Since this drainage report is the same as that submitted for Filing No. 1, my comments are the same.

FINAL DRAINAGE PLAN

THE RIDGE AT LORSON RANCH

FILING NO. 1: SF 22-XX ← SF224

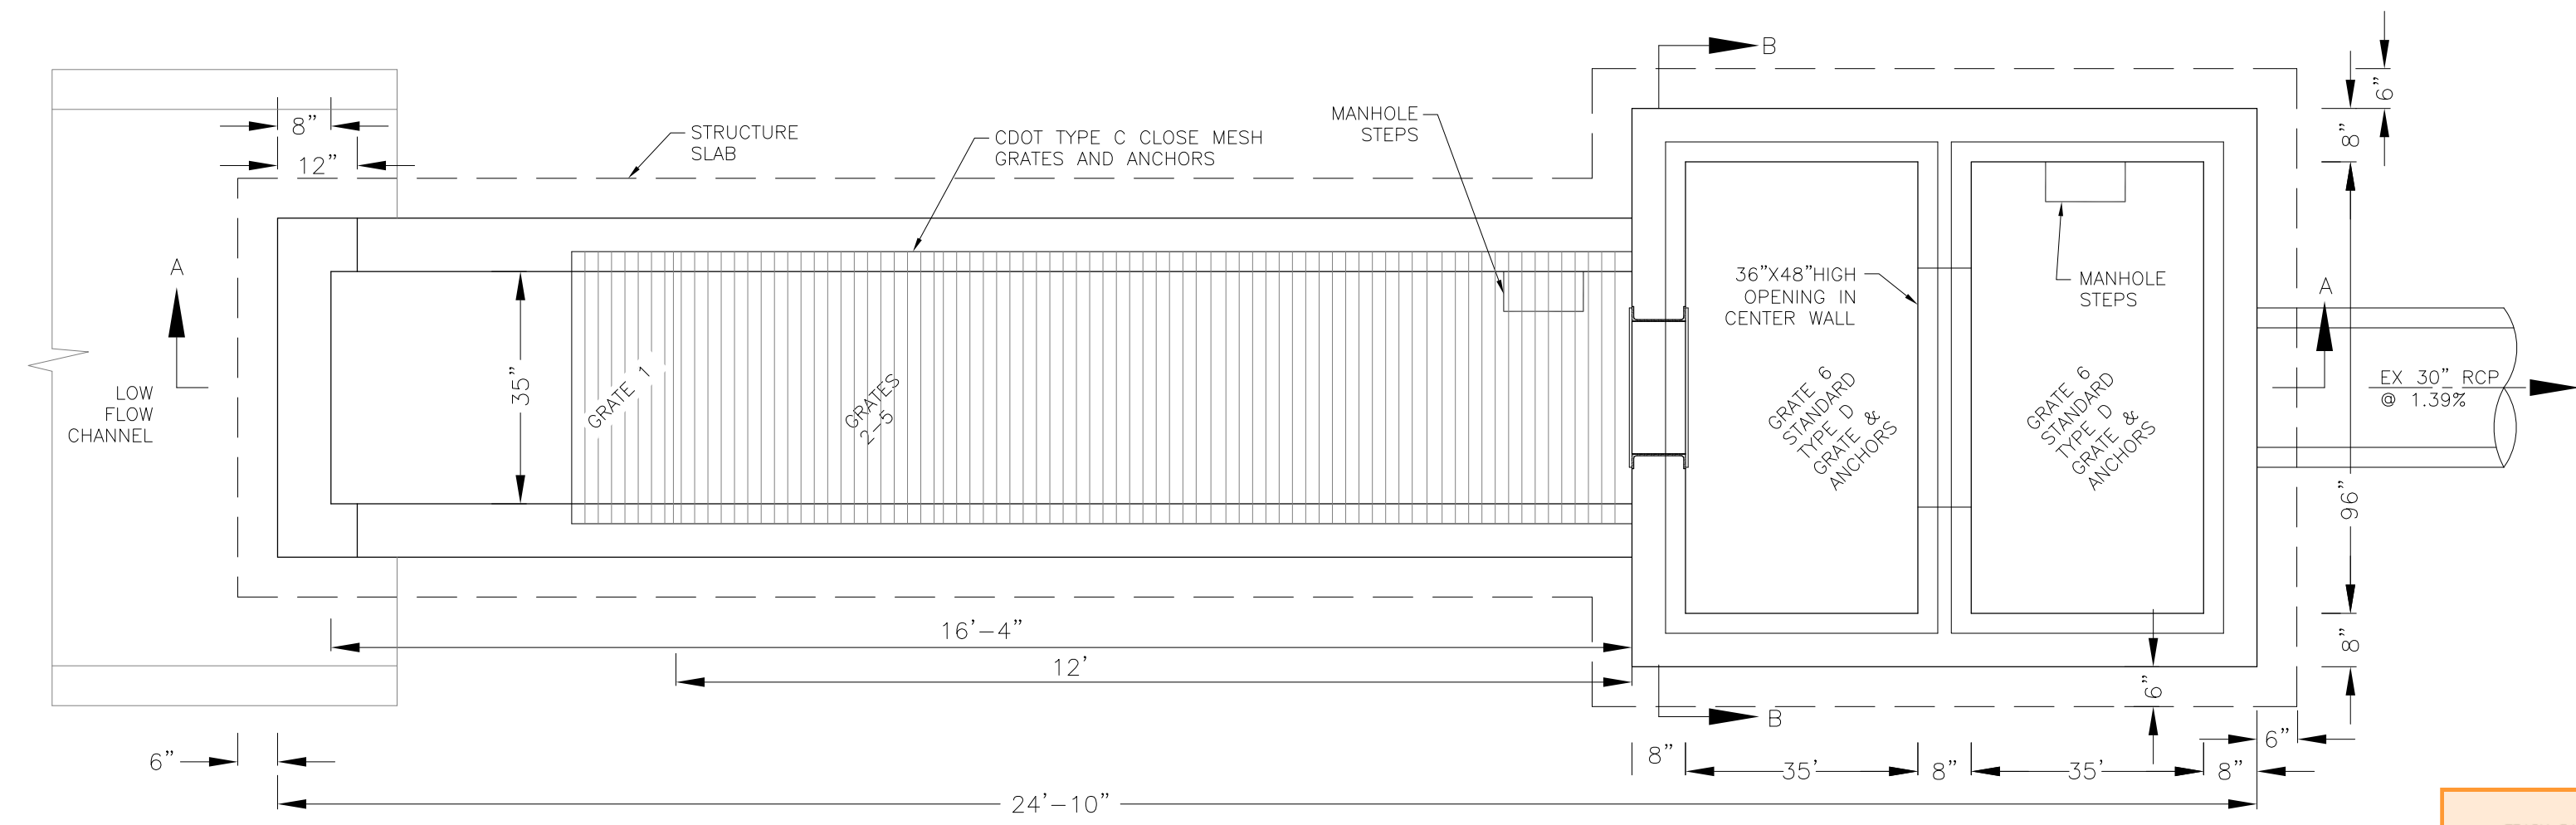
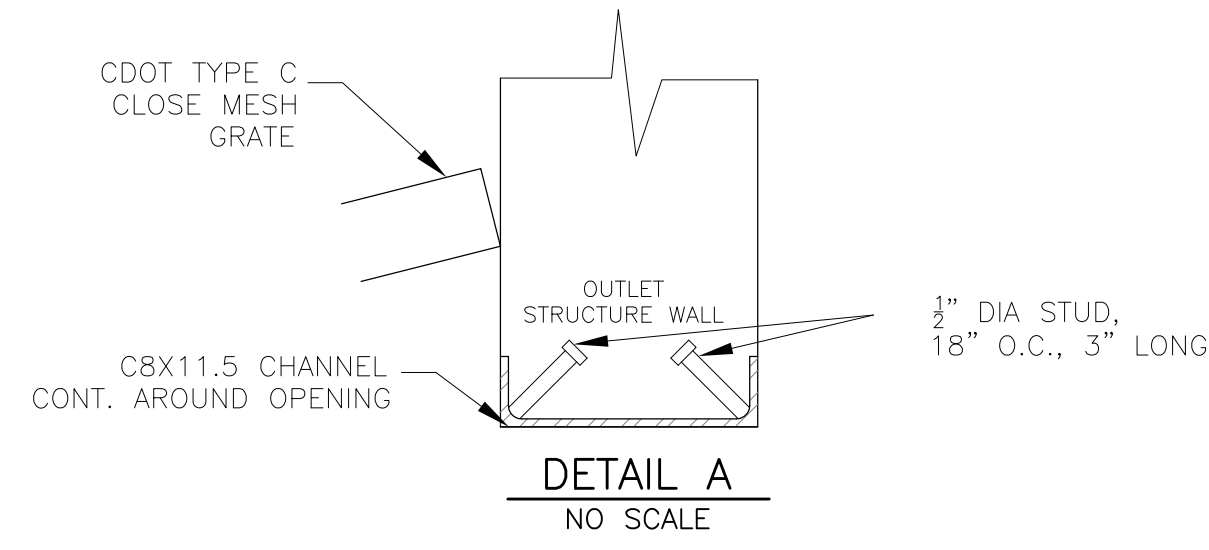
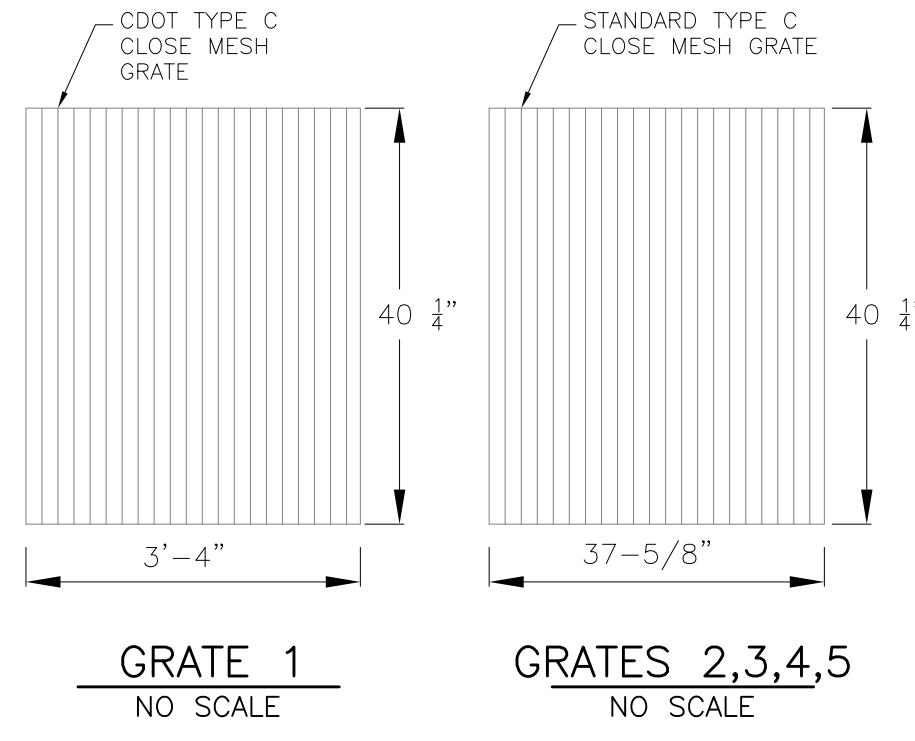
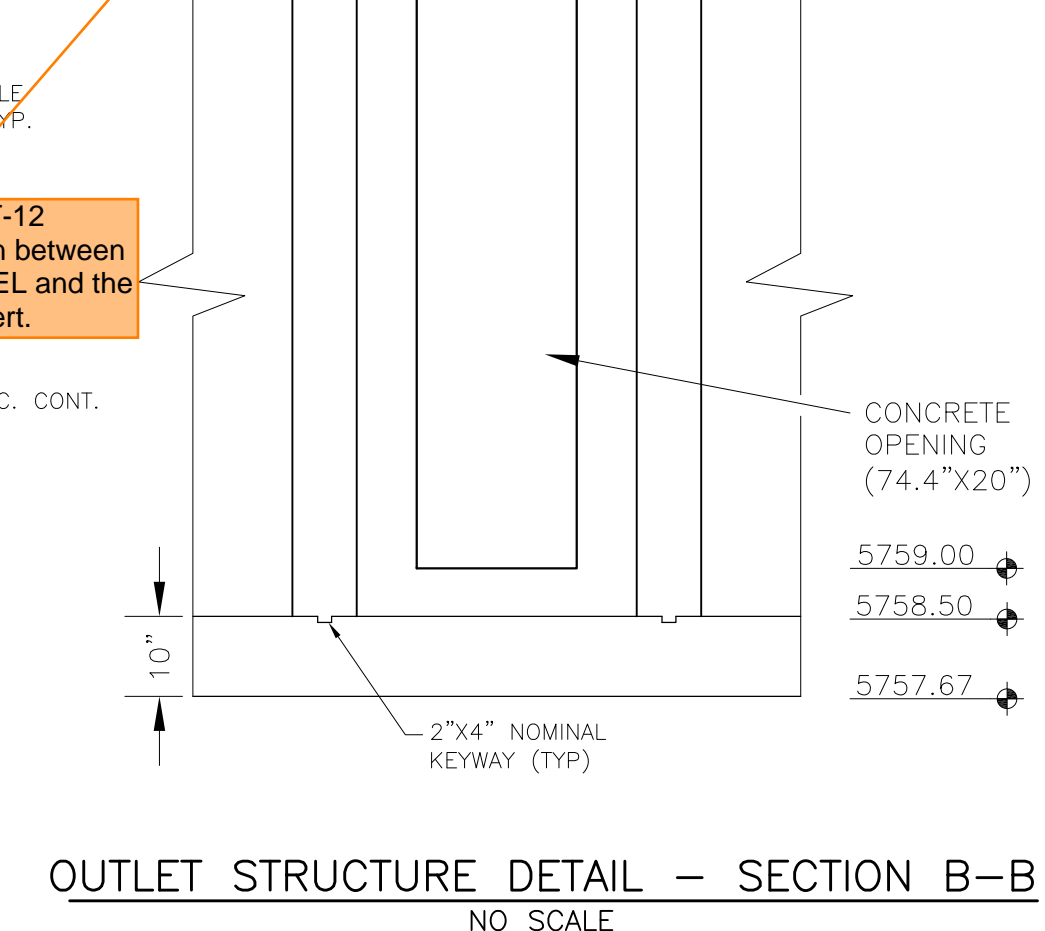
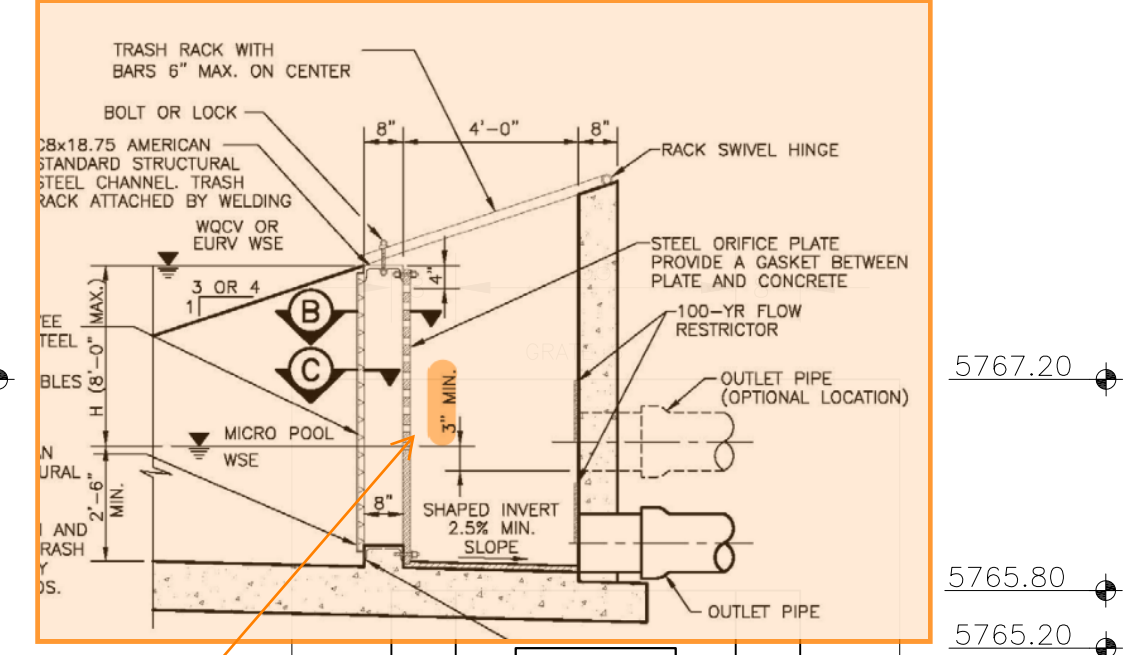
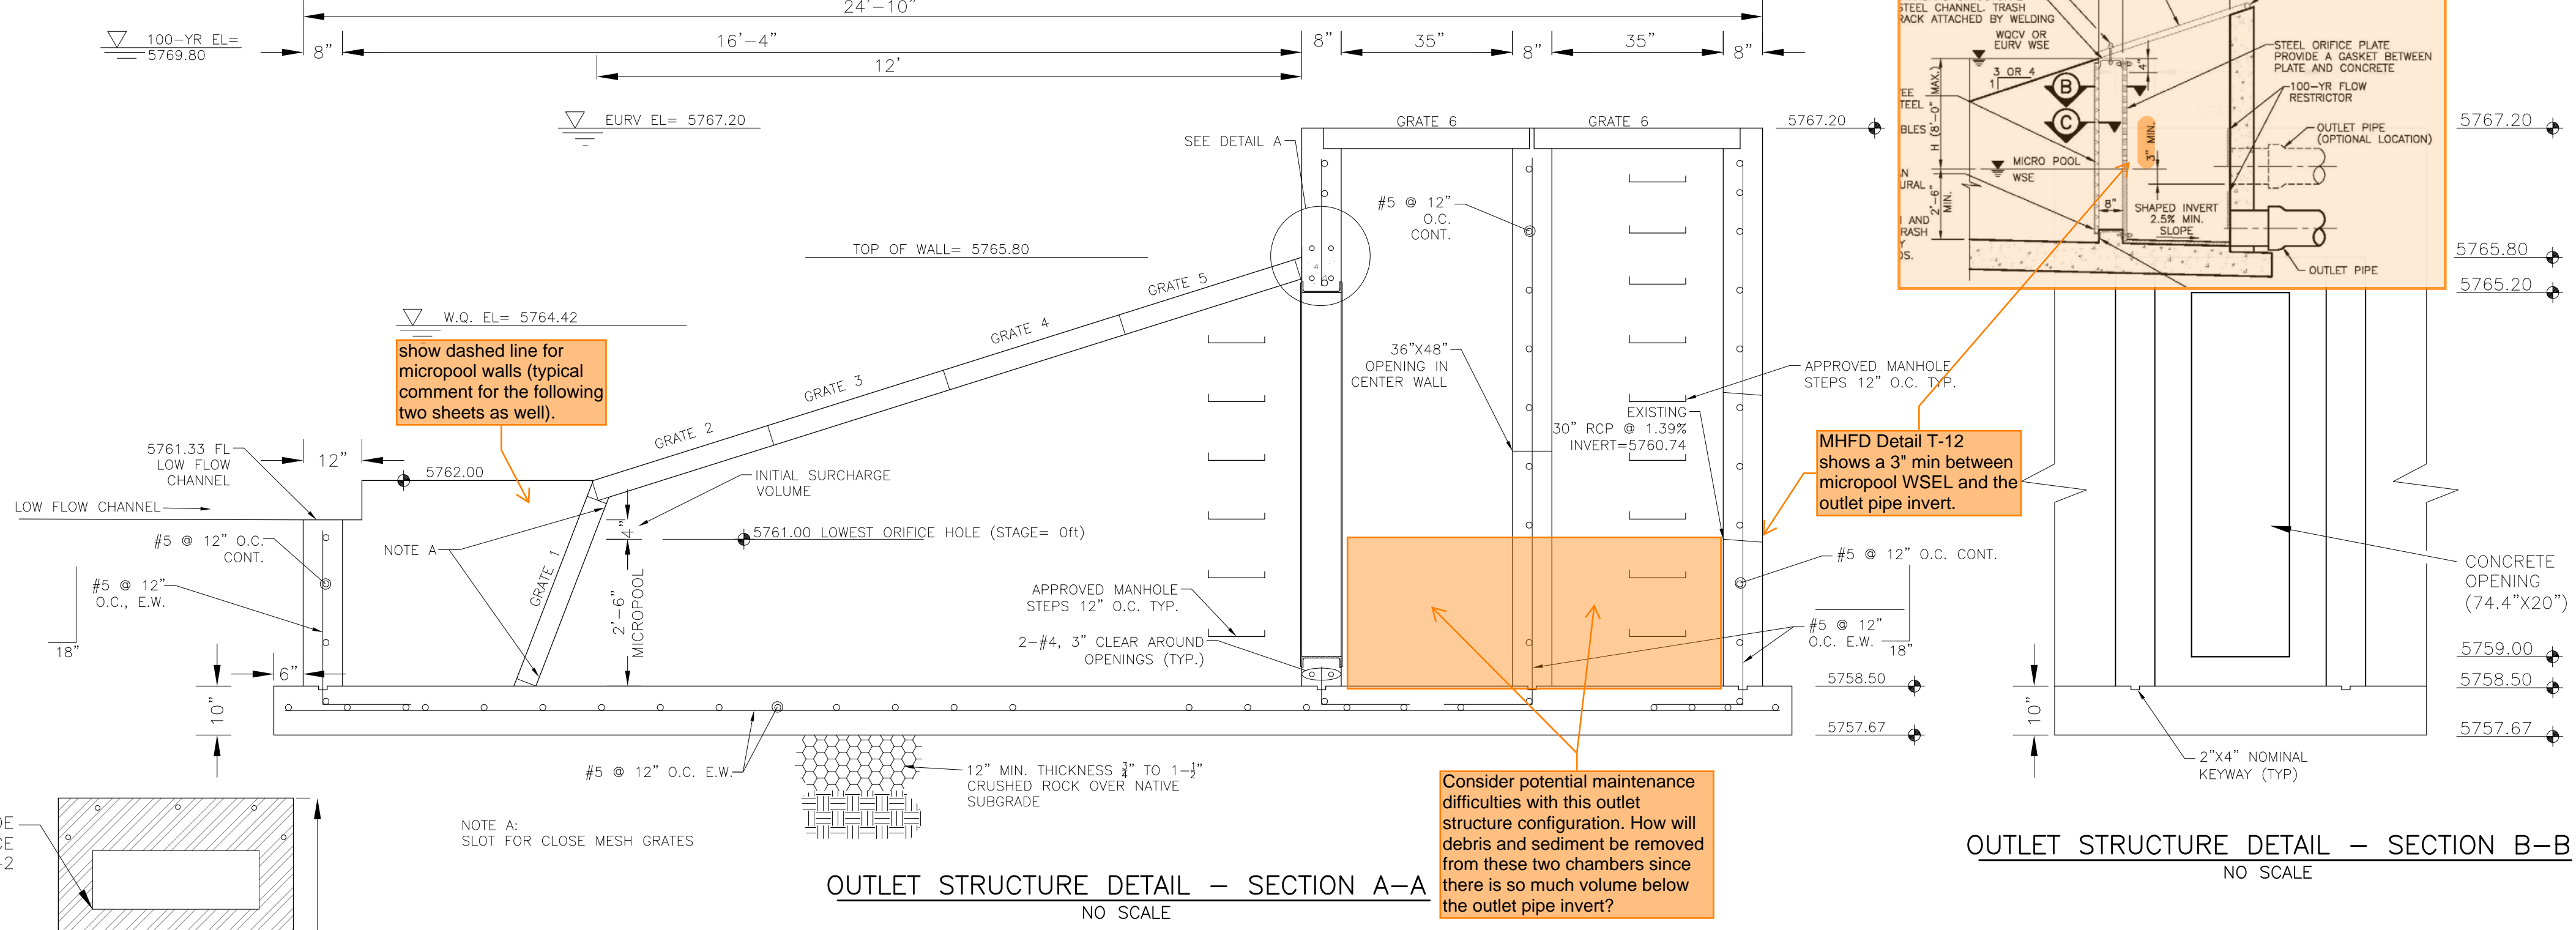
This sheet and the other two sheets below this one need to be included in the CD's.
